LANDMARK COMMISSION

FILE NUMBER: COA-26-000358
LOCATION: 4704 Gaston Ave
STRUCTURE: Noncontributing
COUNCIL DISTRICT: 2

A Certificate of Appropriateness to construct a main structure on a vacant lot.

4704 Gaston Avenue
Dallas, Texas 75246
New Construction

1 **NORTHWEST ELEVATION (FRONT)**
1/4" = 1'-0"

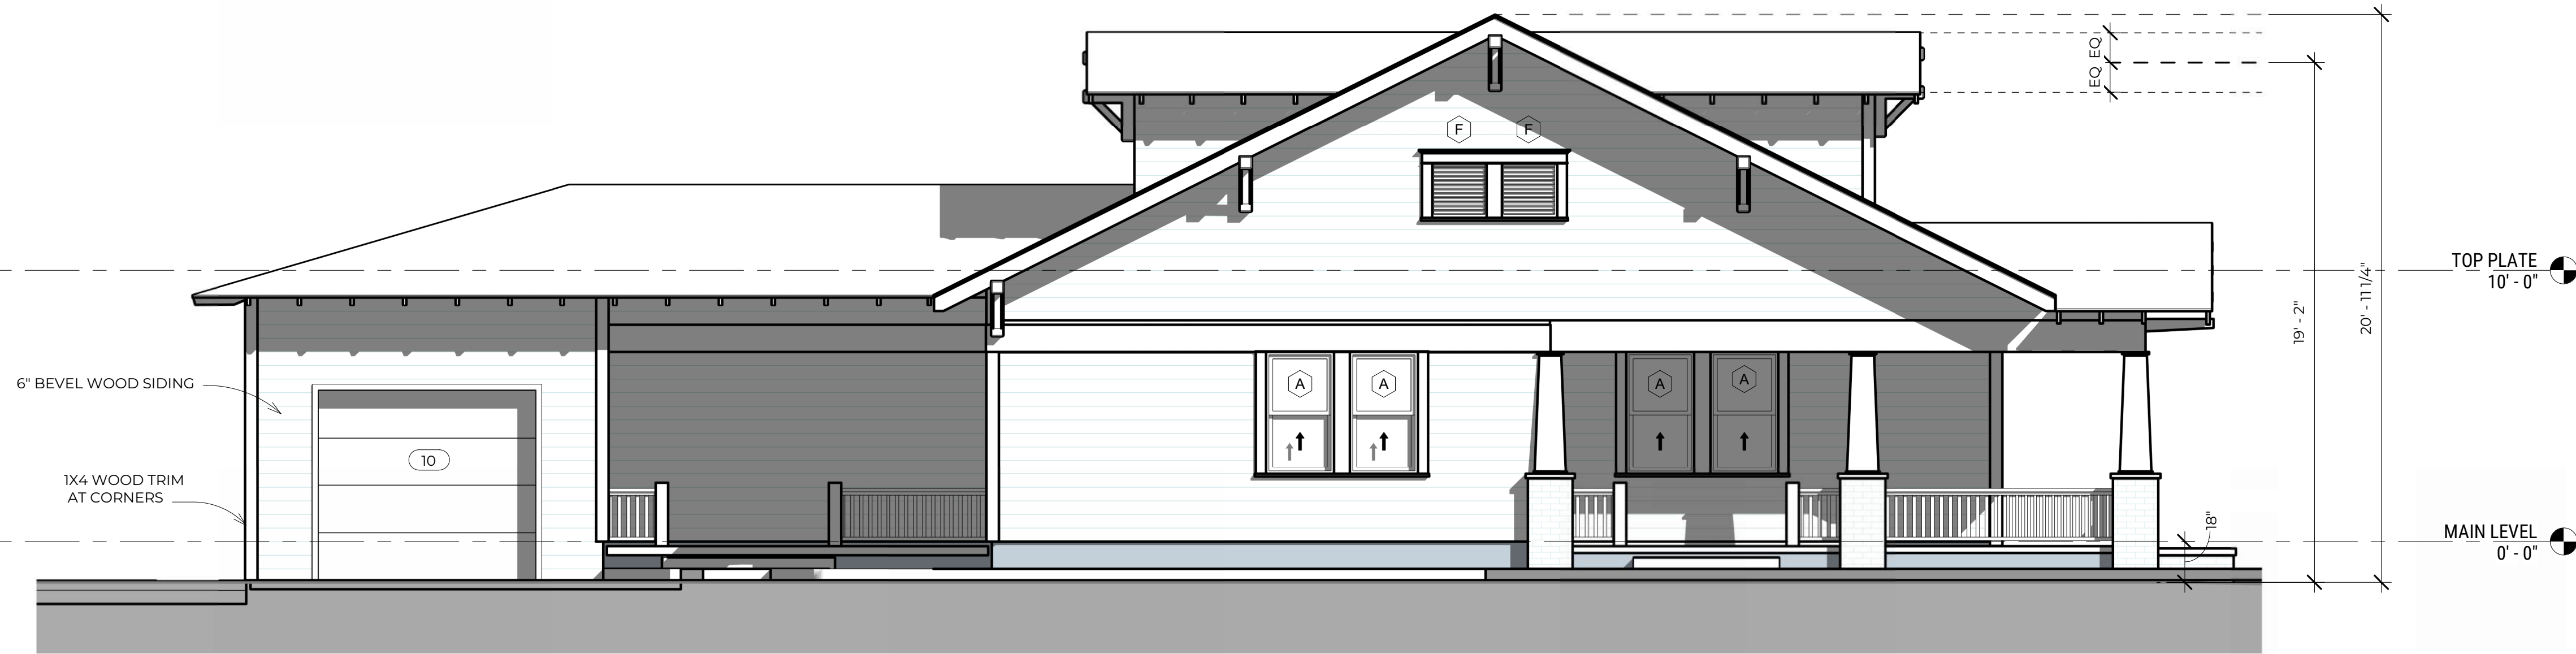
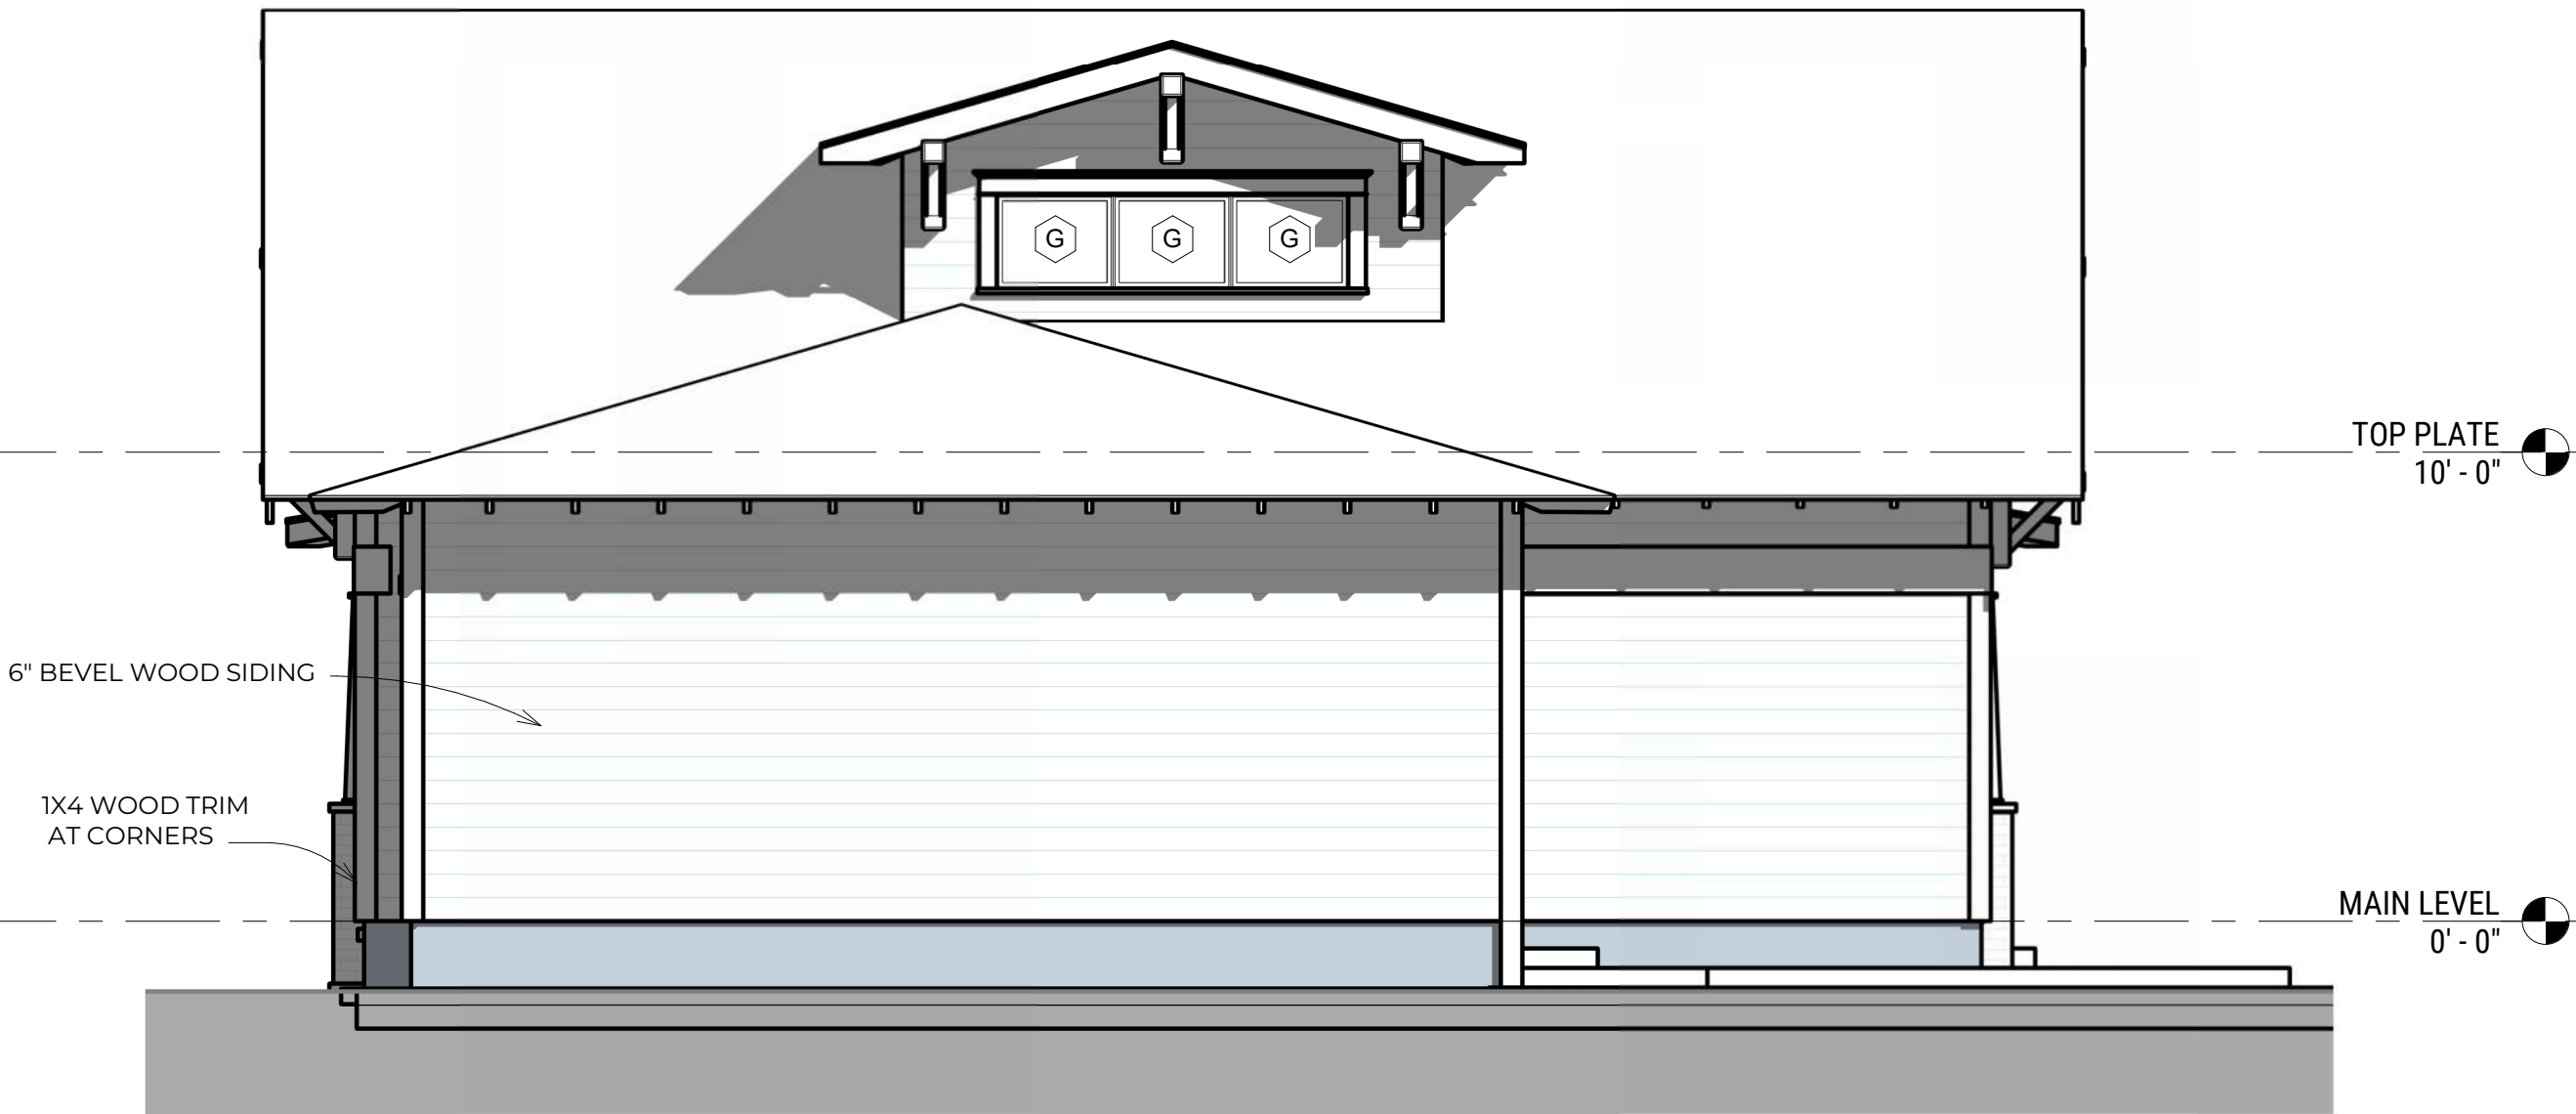
- 1- Column bases should be brick if going to the ground
- 2- The plan with the full length porch gable is preferred as this allows for the columns to lay out better against the fenestrations of the door and windows
- 3- A sidewalk should be added to the front which is 5' wide, beveling at 45 degrees as it approaches the steps, and then as wide as the steps as it advances to the front of the house.
- 4- Steps should be squared, not rounded
- 5- Materials List needs to include beveled lap siding with 6" reveal, Jeldwyn Windows with window survey and labeled on plans
- 6- Garage door should not have raised panels
- 7- Future application should be submitted for paint colors and roof/shingle colors

1. Add sidewalk to front of street facing elevation of porch and add cheek walls to stairs (brick with cast stone top).
2. At two part porch columns add brick at bottom portion.
3. Columns should have brick column bases down to the ground.
4. There should be centered steps on the front of the porch and brick cheek wall on the steps.

Comments: 1- Column bases should be brick if going to the ground
2- The plan with the full length porch gable is preferred as this allows for the columns to lay out better against the fenestrations of the door and windows
3- A sidewalk should be added to the front which is 5' wide, beveling at 45 degrees as it approaches the steps, and then as wide as the steps as it advances to the front of the house.
4- Steps should be squared, not rounded
5- Materials List needs to include beveled lap siding with 6" reveal, Jeldwyn Windows with window survey and labeled on plans
6- Garage door should not have raised panels
7- Future application should be submitted for paint colors and roof/shingle colors

- 1) ADD SIDEWALK TO ~~WALK~~ FRONT OF STREET
FACING ELEVATION OF PORCH - ADD CHEEK
WALLS TO STAIR (BRICK W/ CAST STONE TOP)
- 2) AT 2 PART PORCH COLUMNS ADD BRICK @
BOTTOM PORTION

The columns should have brick column bases down to the ground.

There should be centered steps on the front of the porch. There should be brick cheeks walls on these steps.

They should be cast stone caps on the brick cheek walls and the column bases
